ADDENDUM NO. 2

October 27, 2022

Carey Ridge Elementary Addition & Renovation
16231 Carey Road
Westfield, IN 46074

James Robert Funk
REGISTERED
No.
AR00900003
STATE OF
INDIANA
ARCHITECT

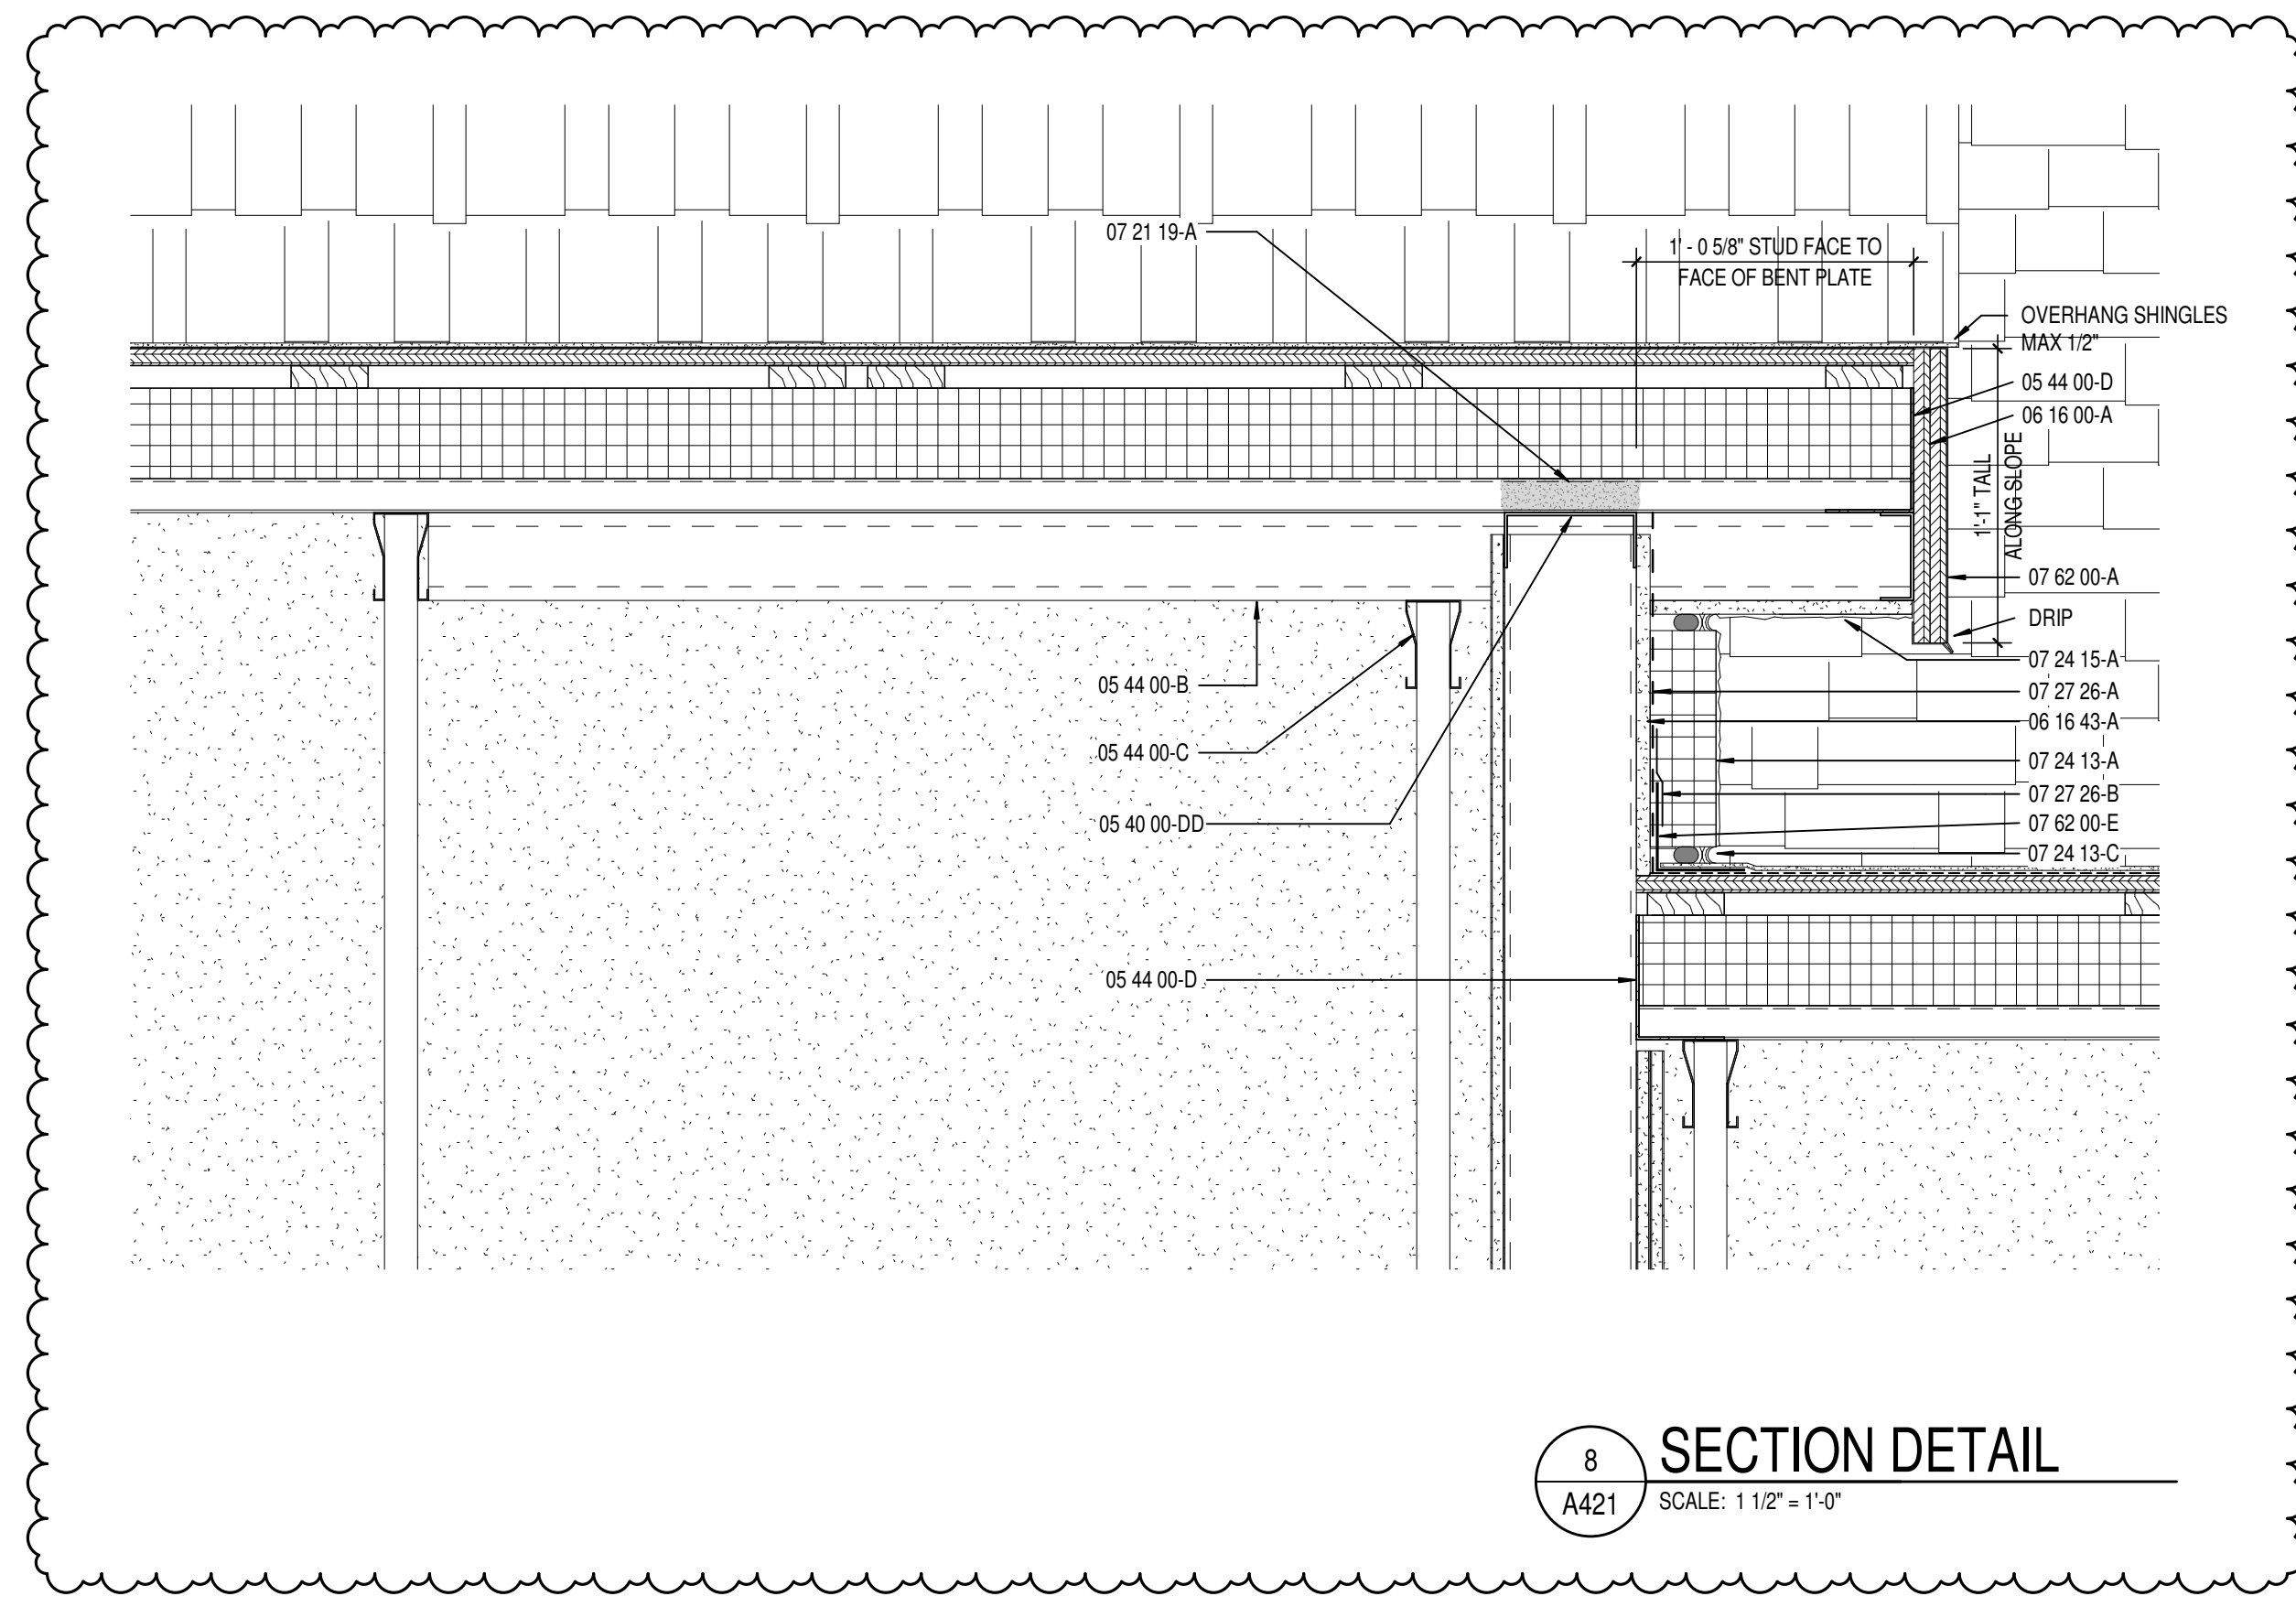
A. Section Detail 3/A420

1. Revised dimensions.

B. Section Detail 3/A420

1. Revised dimensions and keynotes.

DRAWING NUMBER
A611

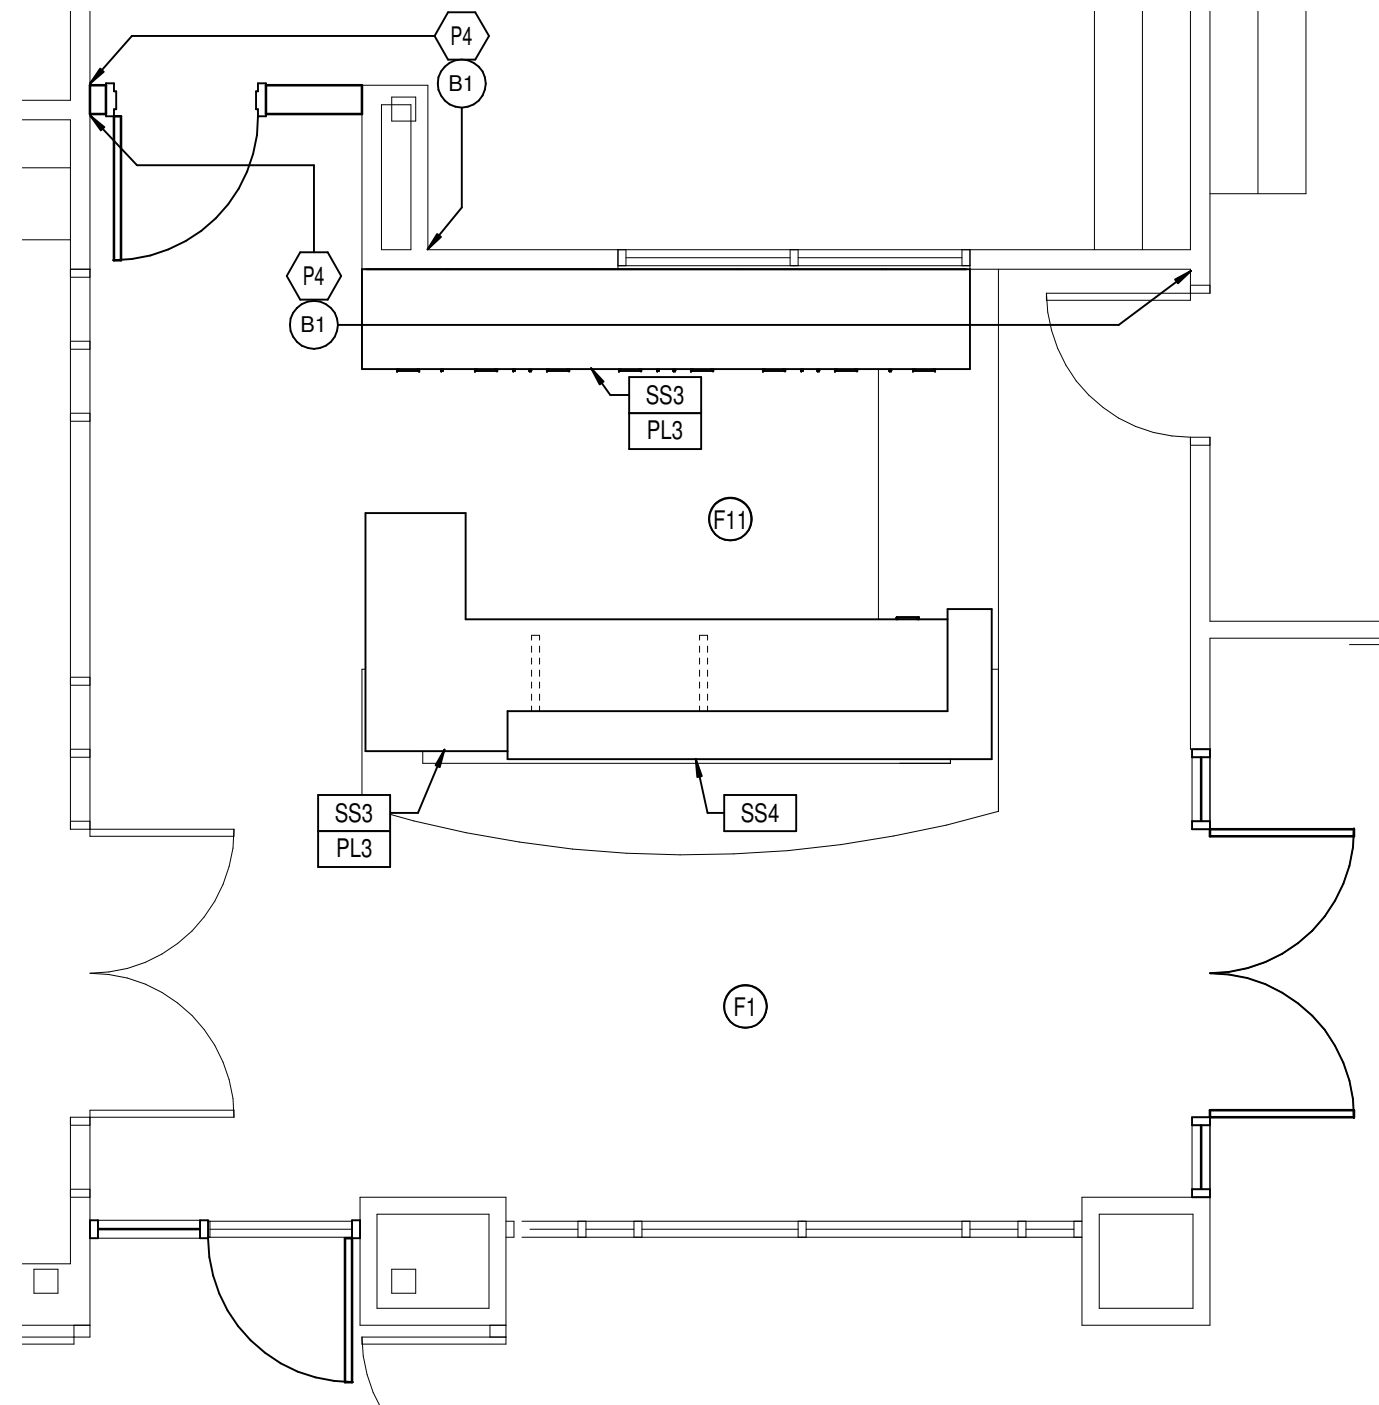
- A. ADD MILLWORK FINISH TAG **PL3** TO 11/A611 MILLWORK ELEVATION AS SHOWN ON REVISED SHEET.
- B. Add drawing notes to document existing electrical devices to remain, new raceway and trenching for electrical devices associated with island desk.

DRAWING NUMBER
A800

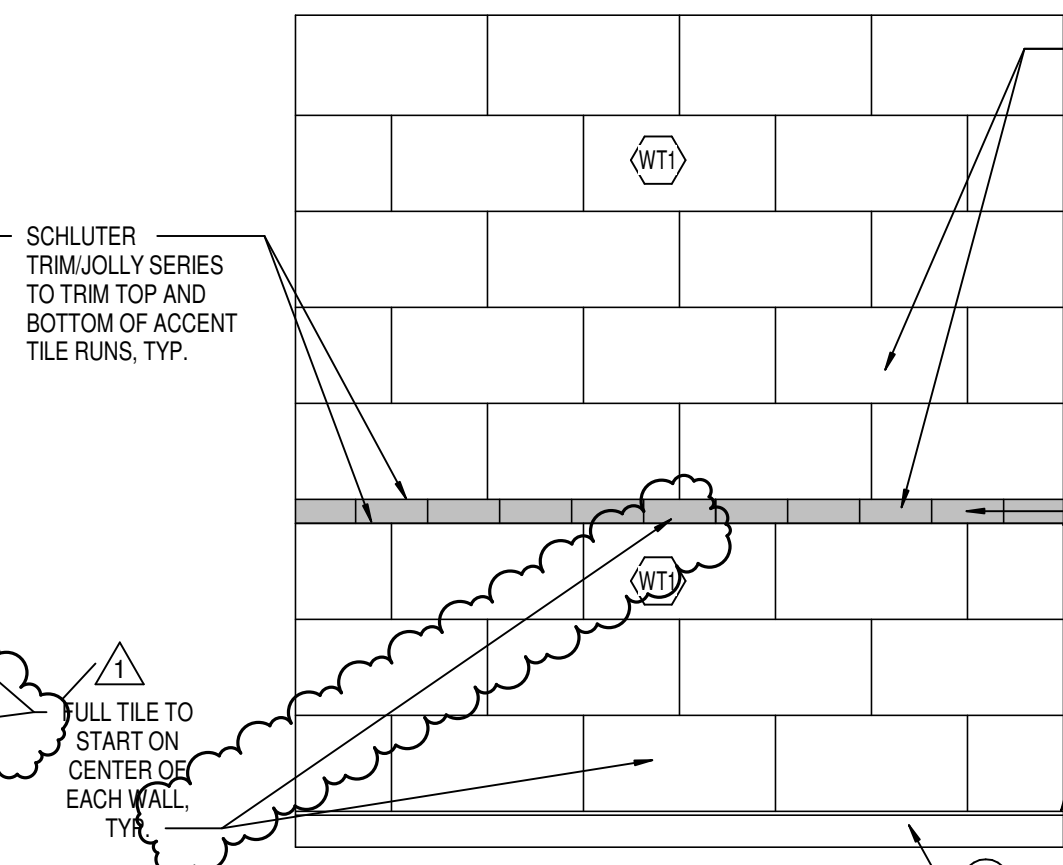
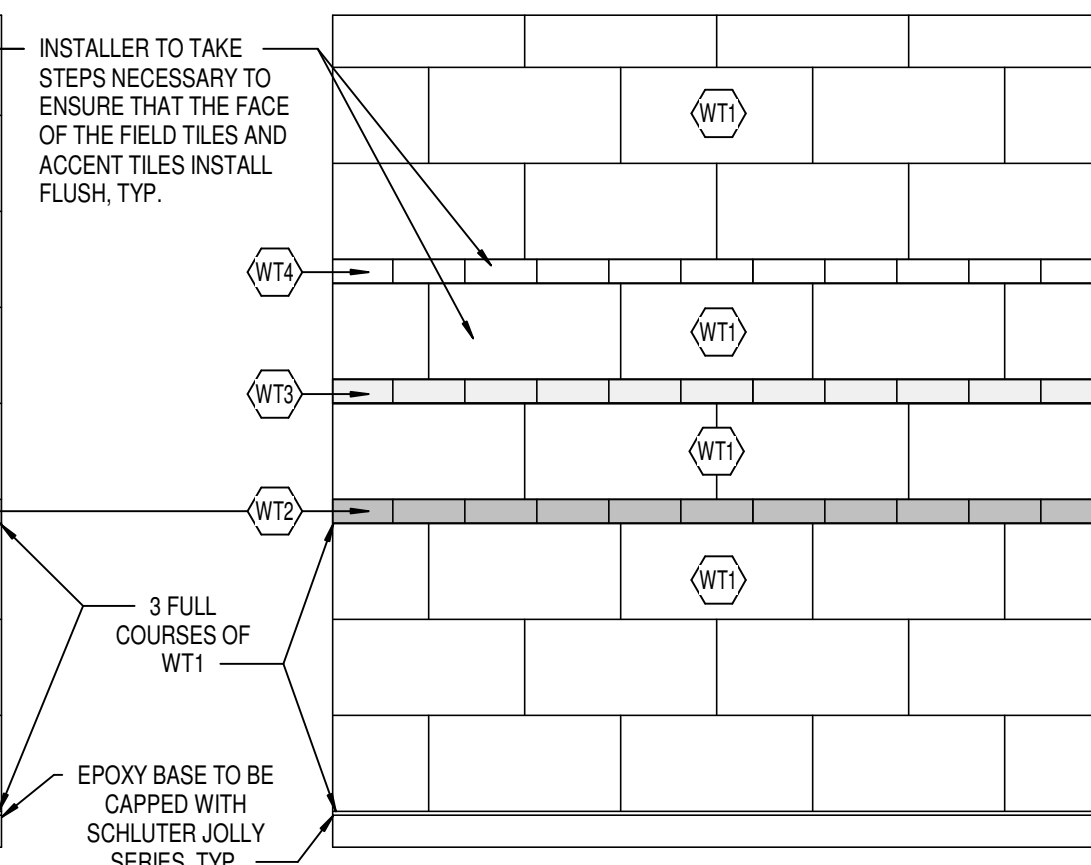
- X. REVISE FINISH PLAN NOTE F12 TO READ "...INCLUDING PAINT COLOR, QUALITY AND FINISH **AND BASE MATCH TO INCLUDE STYLE, HEIGHT AND COLOR. REPLACE BASER FROM NEAREST INSIDE CORNER OR DOOR FRAME TO NEAREST INSIDE CORER OR DOOR FRAME.**"
- Y. ADD LEADER LINES TO ELEVATIONS 2/A800 AND 3/A800 AS SHOWN ON REVISED SHEET.

1 FIRST FLOOR FINISH PLAN - UNIT H
SCALE: 1/8" = 1'-0"

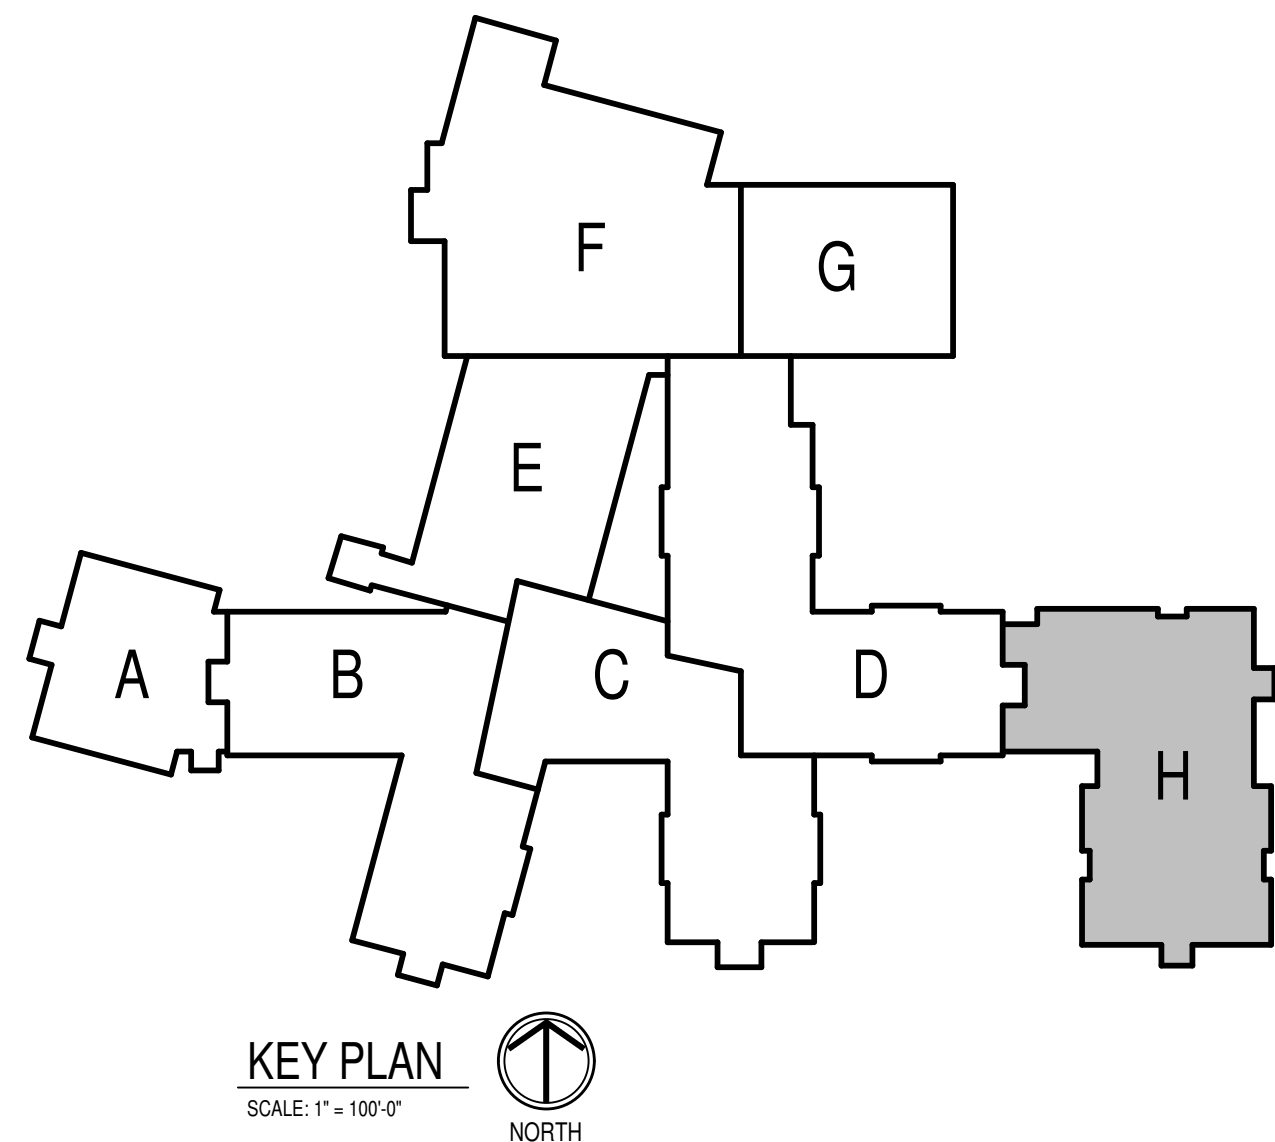
- A. REPLACE ALL INSTANCES OF WALL FINISH TAG P3 WITH WALL FINISH TAG **P1**.
- B. ADD FINISH PLAN TAG **F11** TO CORRIDOR H101 AS SHOWN ON REVISED SHEET.
- C. ADD DIRECTIONAL INSTALL ARROWS TO THE FOLLOWING ROOMS AS SHOWN ON REVISED SHEET: STORAGE H109C, H112, H115C, H122C, H123C, H124C, H125C, H126C, H127C
- D. REVISE DIRECTIONAL INSTALL ARROWS IN VESTIBULE H108 AS SHOWN ON REVISED SHEET.
- E. ADD WALL FINISH TAGS **WT1** AND **WT2** TO TOILET H118.

DRAWING NUMBER
A802

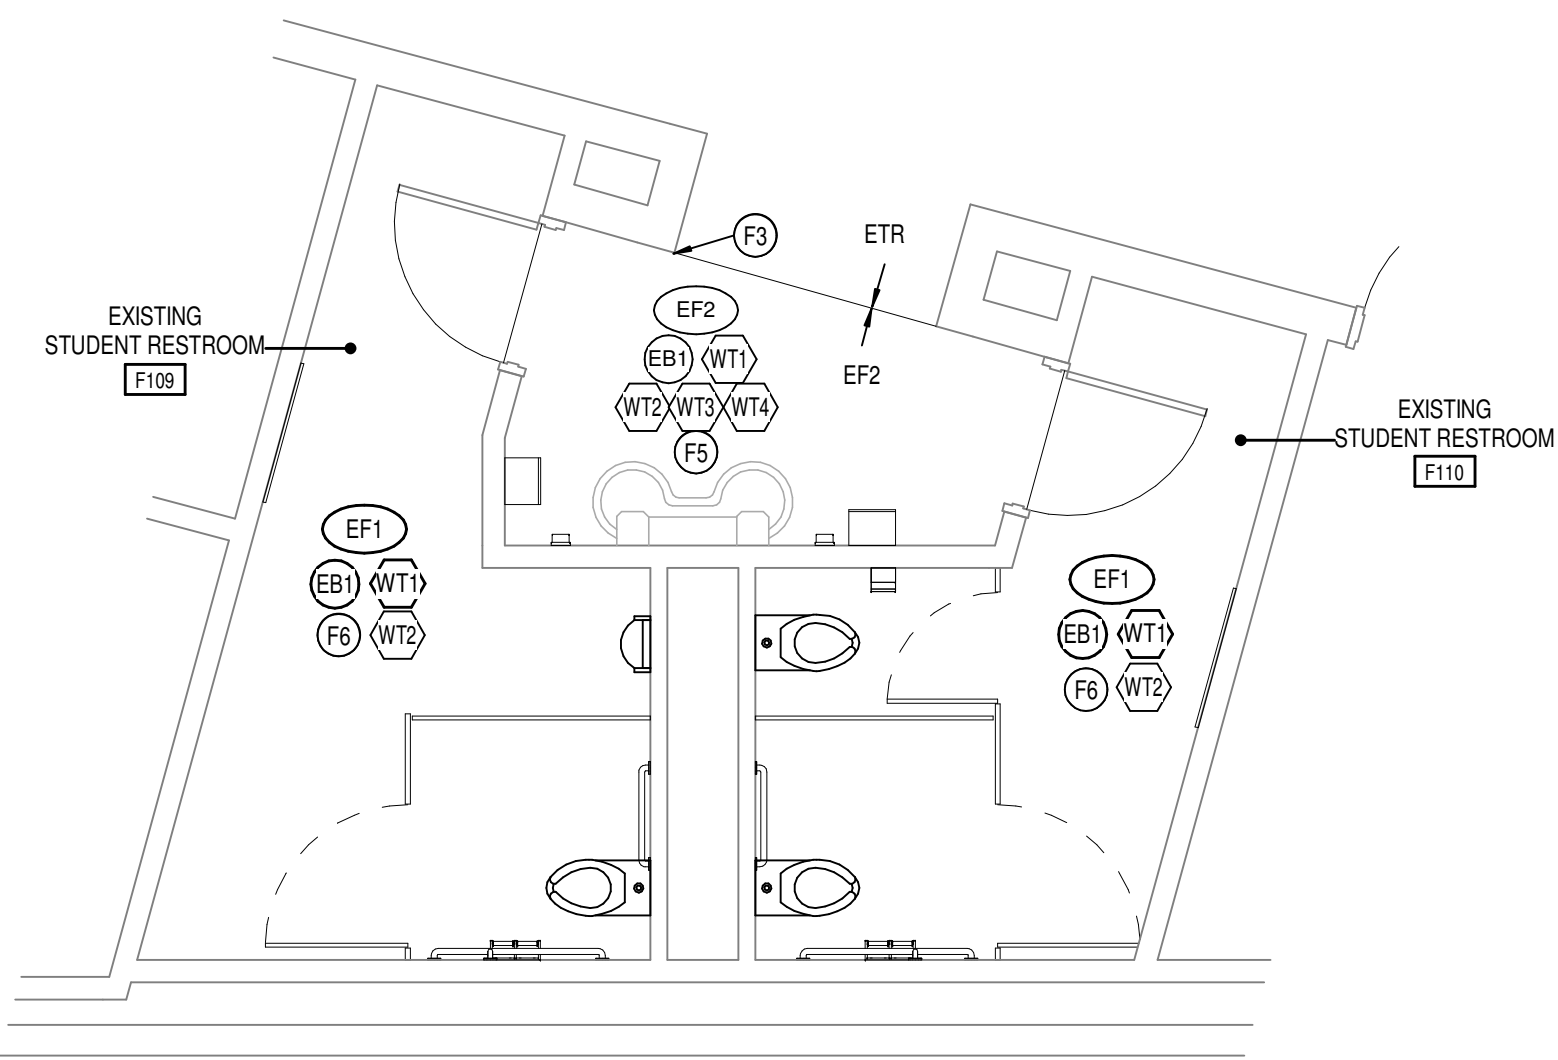
- A. ADD FLOOR FINISH TAG **EF2** AND FLOOR FINISH EXTENTS TO EXISTING NURSES RR E111A.
